FIELD CHANGE ORDER

NO. 18-014

MANUFACTURING EFFECTUATION FPA 801/02/29 and up	EQUIPMENT AFFECTED RC8000 RC 8401/FPA 801 Front End Processor Adapter
NOTE

SCOPE Due to unstability in the 74S124 main oscillator this oscillator has been replaced by an AGATRONIC oscillator.

Circuit : KT - 512 8 MHZ OSCILLATOR + 100 KHZ OSCILLATOR

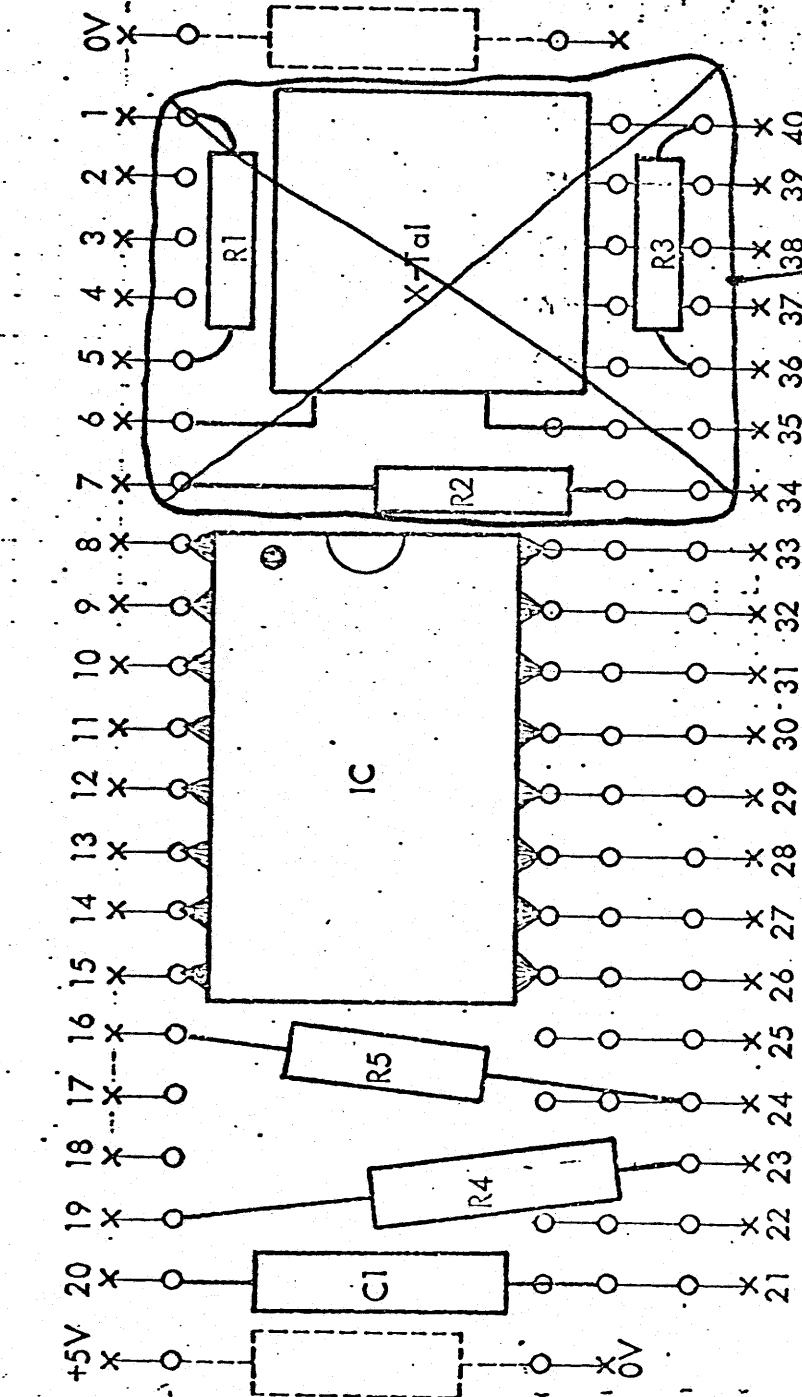
FIELD INSTRUCTION	CONT'D ☐
1. Rebuild KT 512 in IC-position 90 as shown on pages 2 and 3. New KT circuit is called KT 584. 2. Remove and install new wires as shown on enclosed Hardok formular 22. 3. Mark the FCO-label with 18-014.

1. Remove R1, R2, R3 and X-Tal

2. Remove the crossed out wires

3. Install new IC 2 and new wires as shown on page 3

Provisional

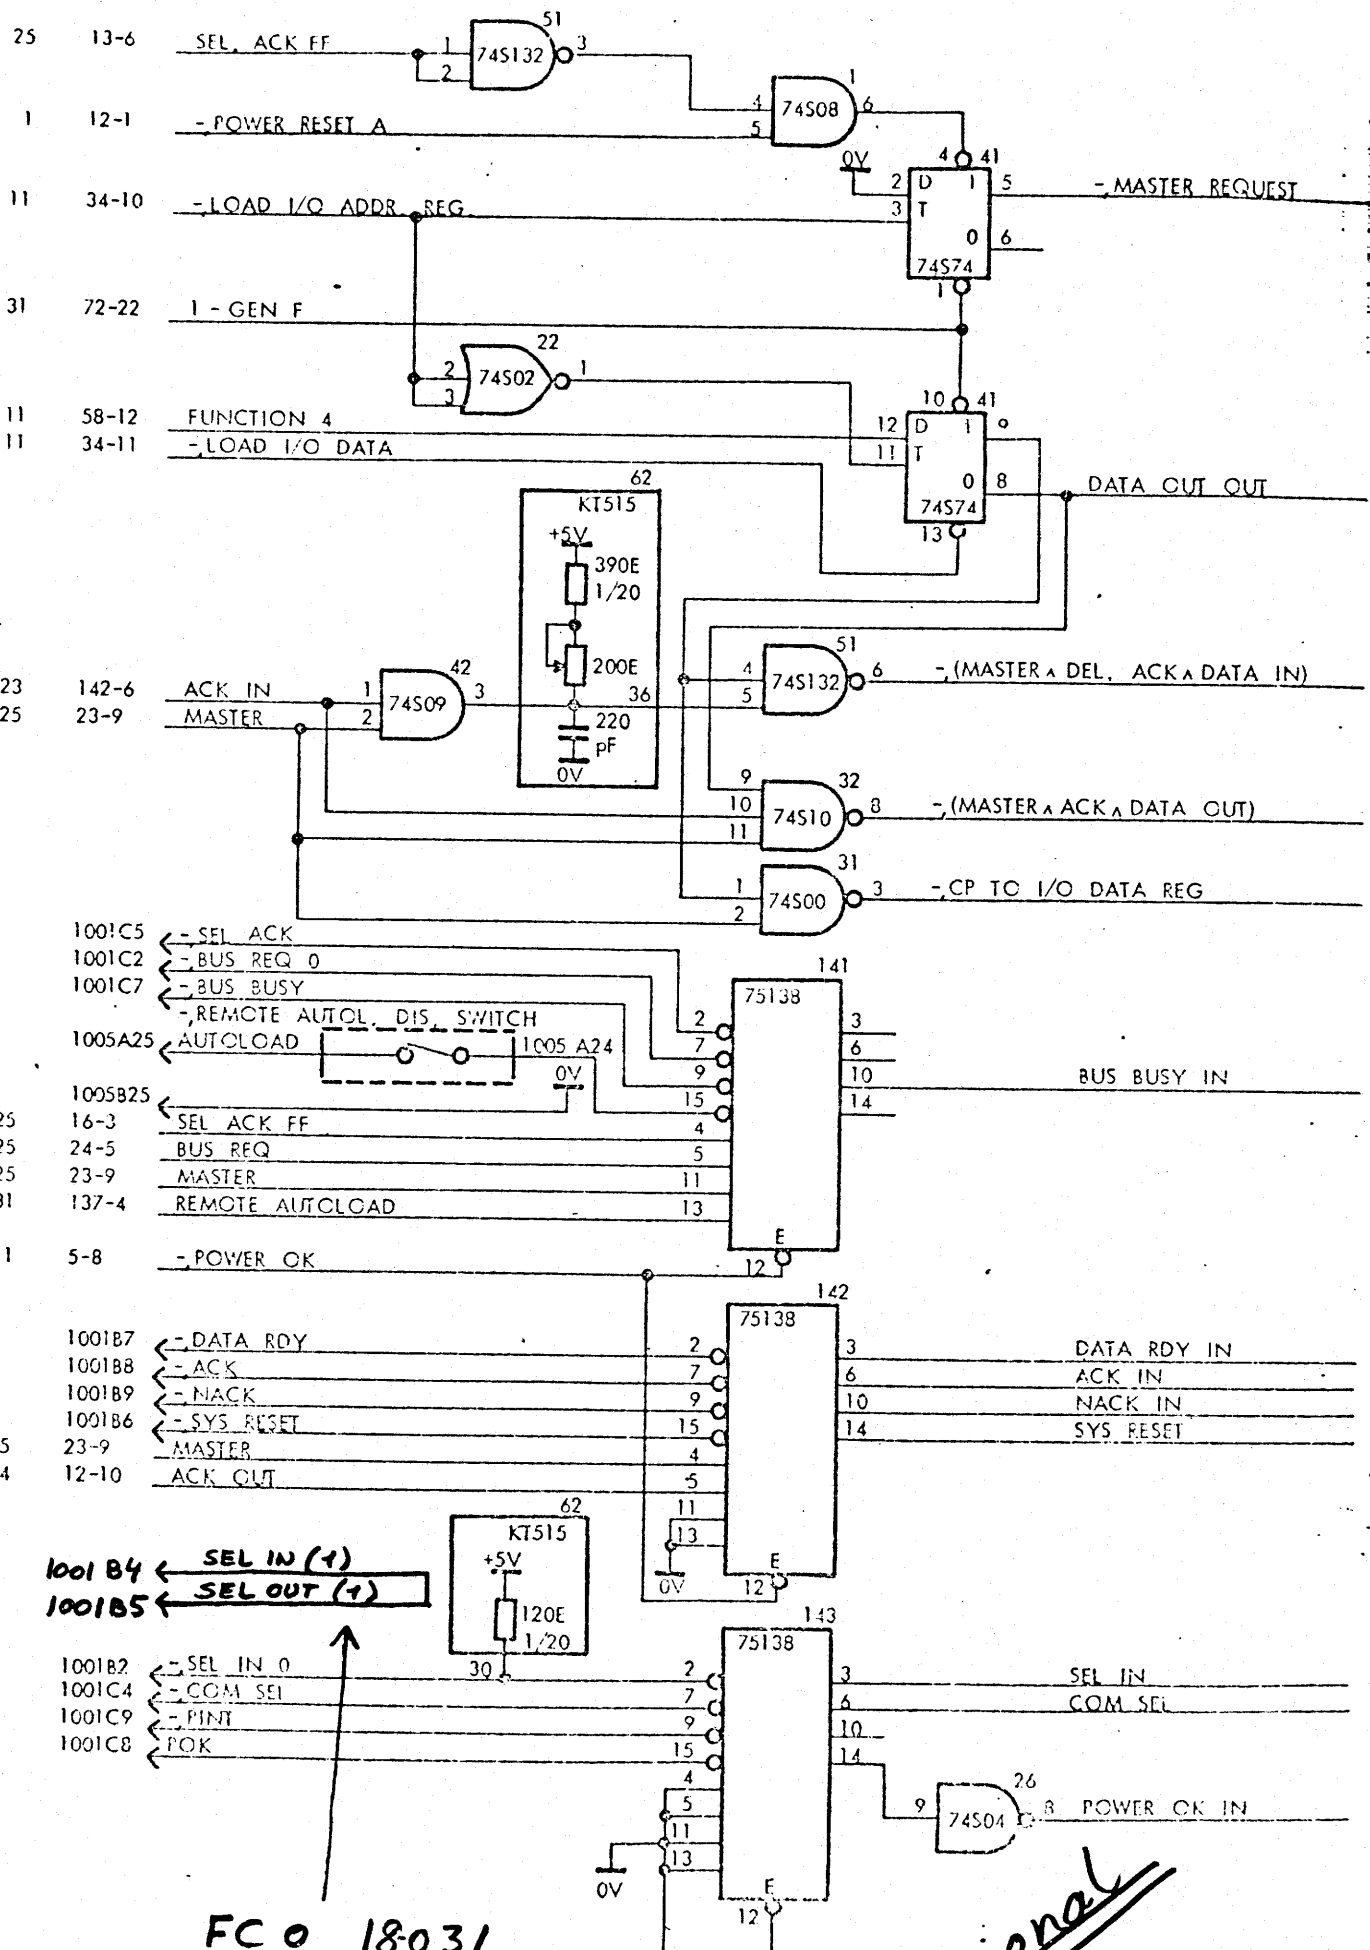
REASON FOR CHANGE
This modification relays the SEL IN (1) signal from the BCU.
DESCRIPTION OF CHANGE
1. Insert a connection from (1001-B4) to (1001-B5)
2. Code the FCO-label 18-031
ADDITIONAL COMMENTS
